**Springwood Development Nominees – Supermarket**

DA 490/E006/19

## OVERVIEW

## **ASSESSMENT REPORT**

SITE PLAN  
1:400

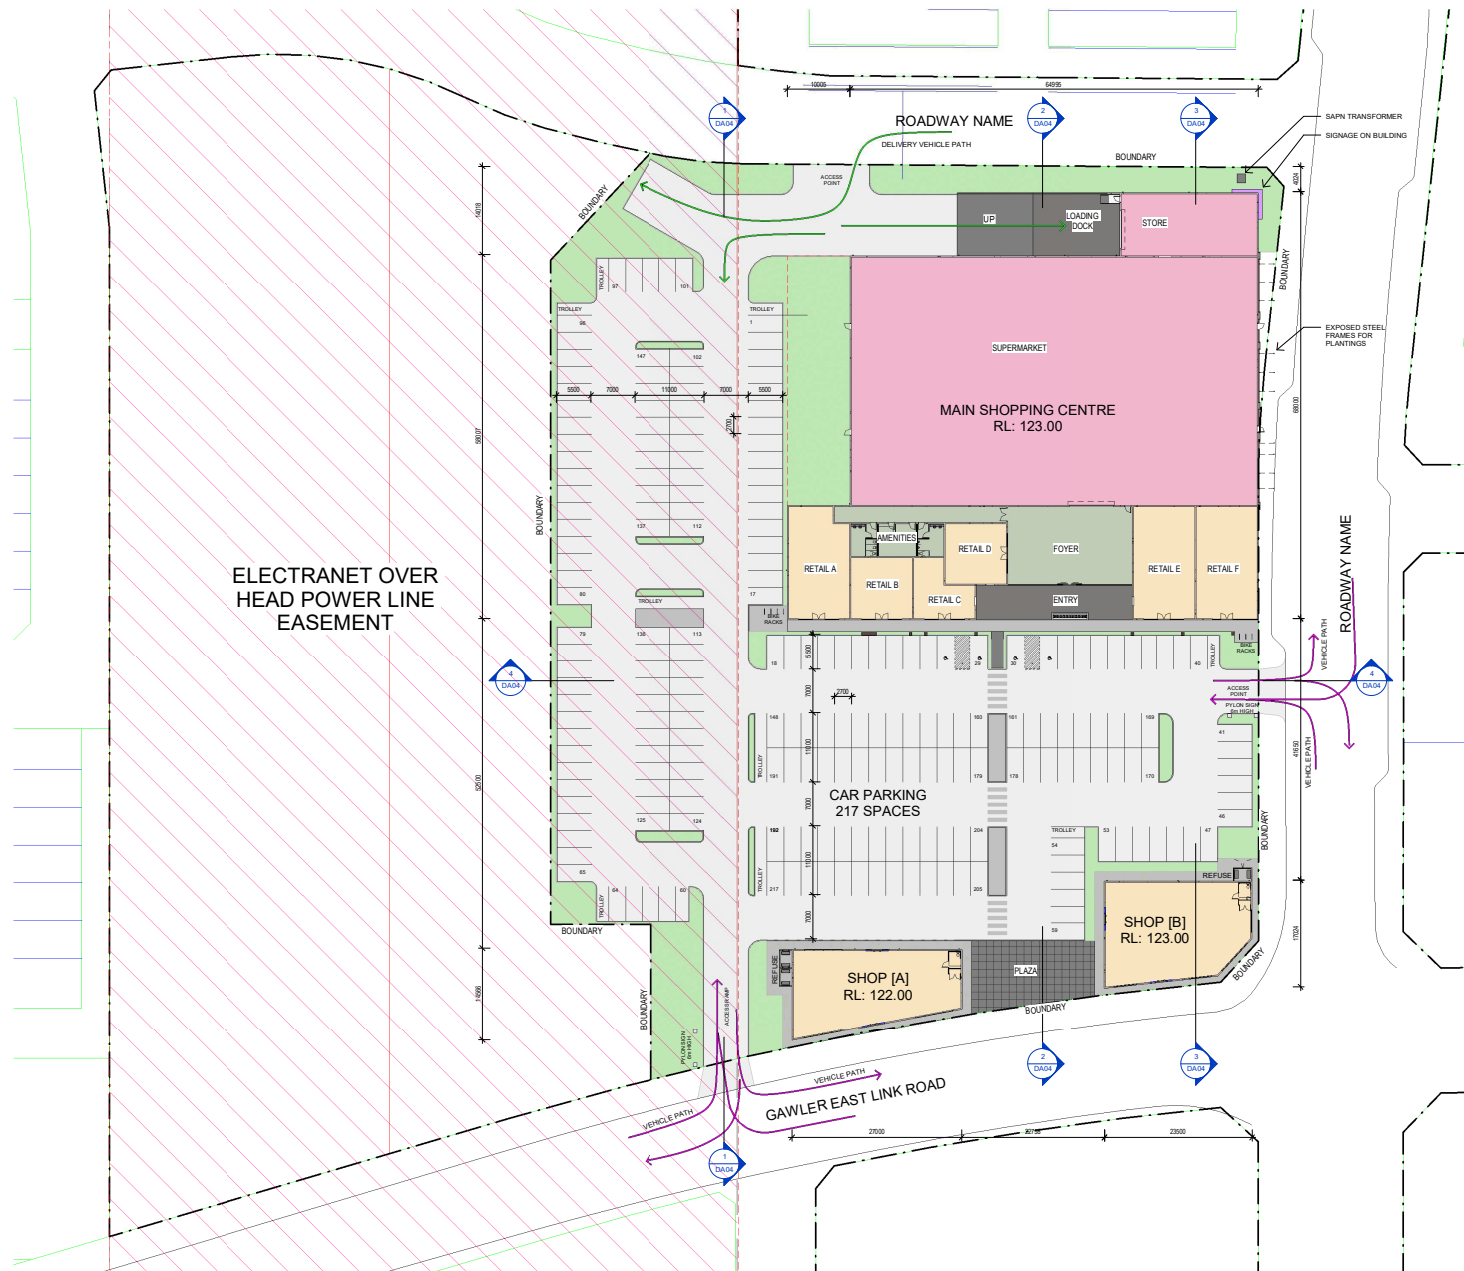
The loading dock location is supported by the council, however, this area could be improved by better landscaping screening. In addition, Council has requested that consideration be given to including improved pedestrian linkage on site. A condition of approval is attached, requiring the applicant to prepare a detailed landscape plan to the satisfaction of the relevant authority.

- *Feature steel frames* –Council has requested additional clarification on the detail of the steel feature frames on the eastern side of the supermarket. In response, that the applicant has advised that the Site Plan has been updated to show the steel feature frames. On this basis, we consider that sufficient information has been provided.

- *Additional pedestrian link* –Council has suggested that an additional pedestrian link could be provided to the eastern roadway. However, we note that the plans already show a pedestrian linkage from the eastern boundary (Gawler East Link Road) which runs along the front of the shops. For this reason, another pedestrian linkage is not considered warranted.

- *Bicycle parking* – as suggested by the Council, bike parking has been identified on the amended plans.

A condition of approval is attached, requiring the applicant to prepare a 'Site Works Plan' to the satisfaction of the State Commission Assessment Panel.

3. Prior to development approval, a detailed landscaping plan shall be prepared and submitted to the satisfaction of the relevant authority for the designated landscaped areas and include the following:
  - Landscaping improvements to on the perimeter of the site;
  - Landscaping and tree species associated with the car park;
  - The location and species to be planted and irrigation methods; and
  - Pedestrian access and egress arrangements

**Figure 2.1** Location of representors (red) with indicative location of supermarket (blue)

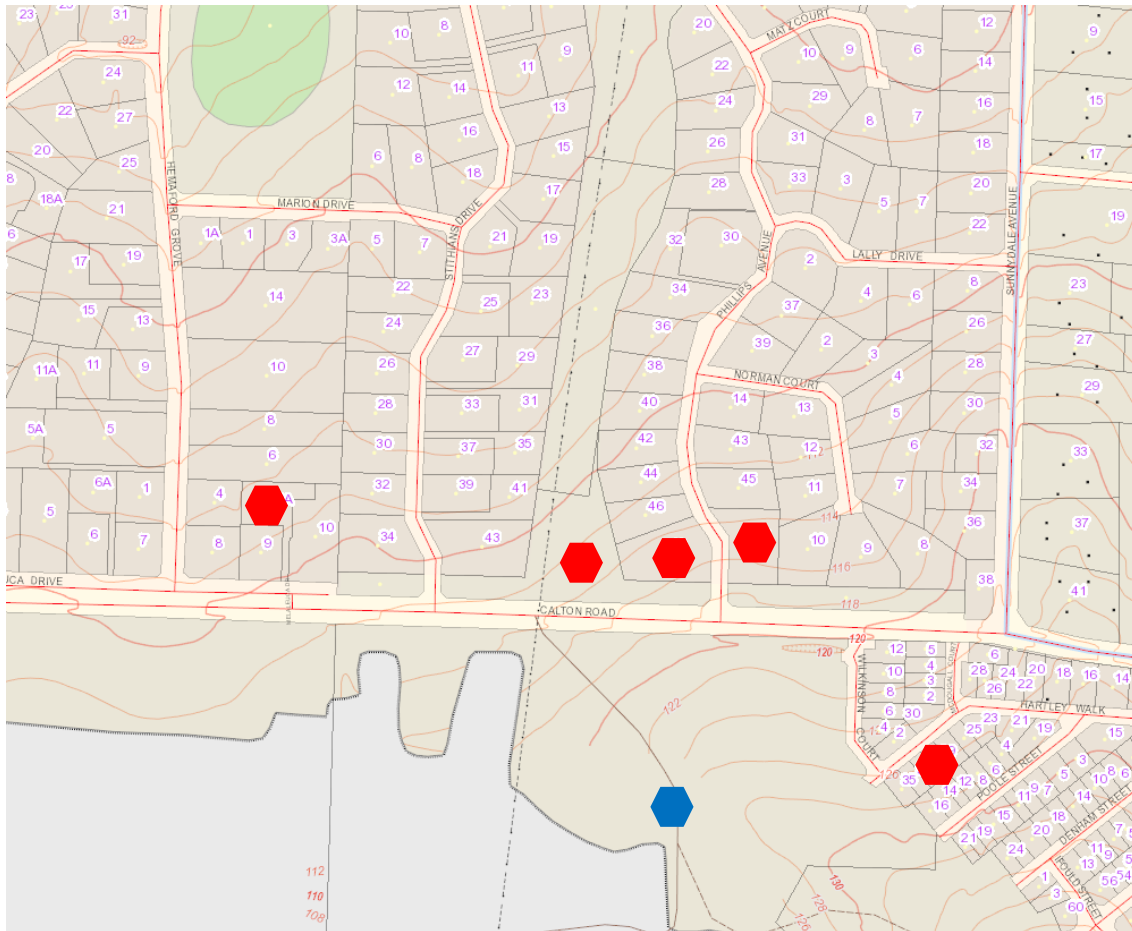
Following the Category 2 public notification process, five (5) representations were forwarded for the applicant's response. The location of the five (5) representations received is identified on **Figure 2.1** and **Table 2.1** below.
